**3651 N. I-35 Retail
CONCEPT PLAN CP1811-001**

REQUEST: Approval of a Concept Plan

DATE OF REVIEW: December 5, 2018

3651 N I-35 RETAIL CONCEPT PLAN

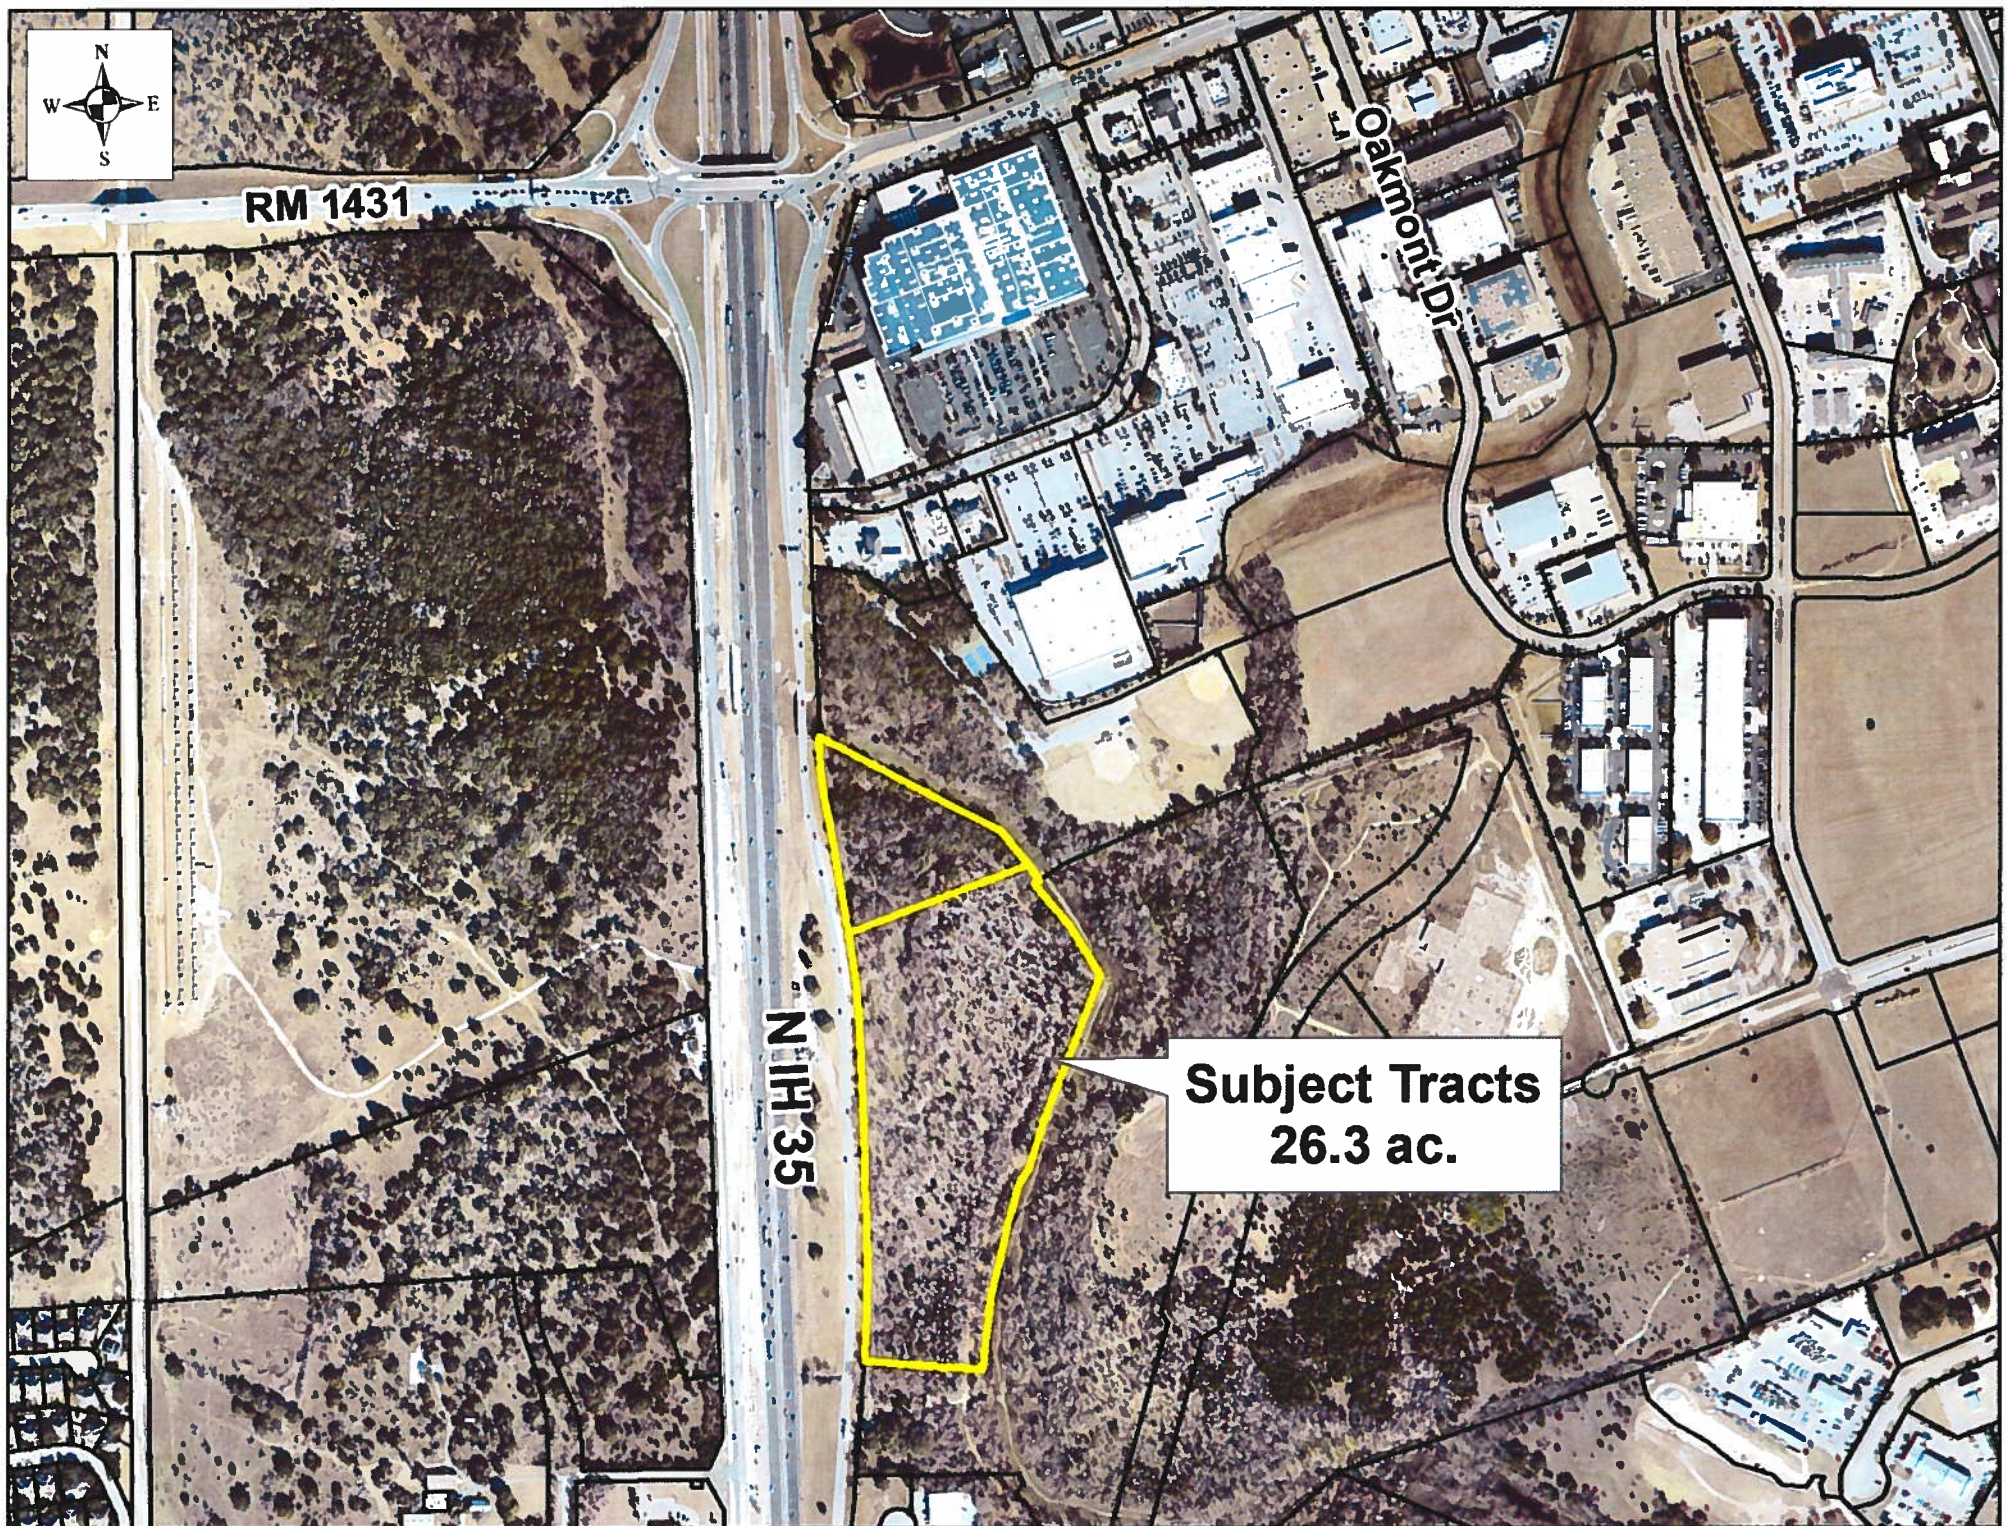
1. Update the concept plan by providing a written scale 1-inch = 100 feet.
